TECH TIPS

Because of installation inconsistency, with the VanHool fuse holders. It is therefore necessary to inspect the installation of these fuse holders to make sure that the system complies with the design specification. The inspection applies to the fuse holders in the right front dash electrical box. In (figure 1) shows the correct installation. In (figure 2 & 3) are the two possibilities of the incorrect installations.

Figure 2

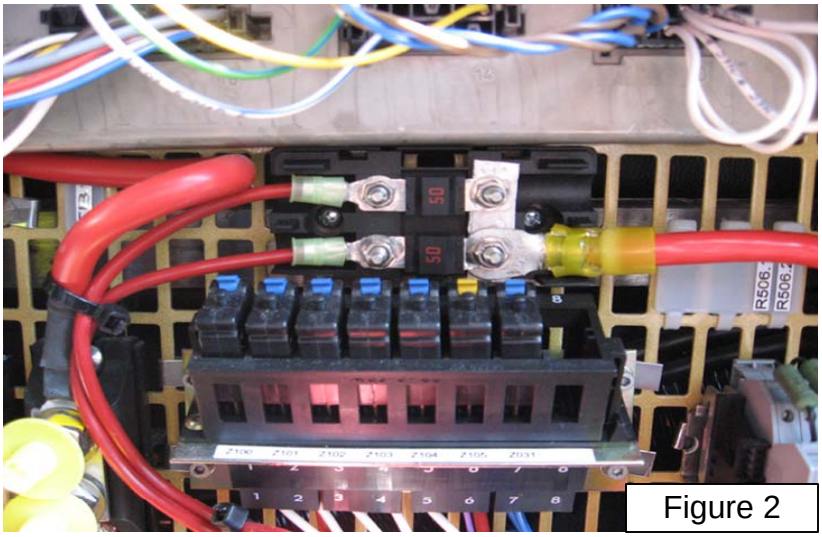
Here in figure 2 has the wrong fuses installed with two 50 amp fuses. They need to be replace with 30 amp fuses part number; 10930132.

Figure 3

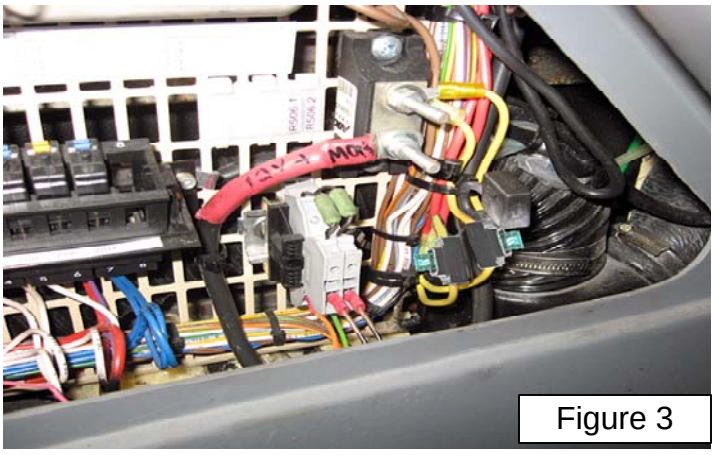
Here in figure 3 there was two inline fuses use that to be replace with the following part numbers; 10930132 (30 amp fuse) & 10947652 (4 fuse block, needs to be cut in half).
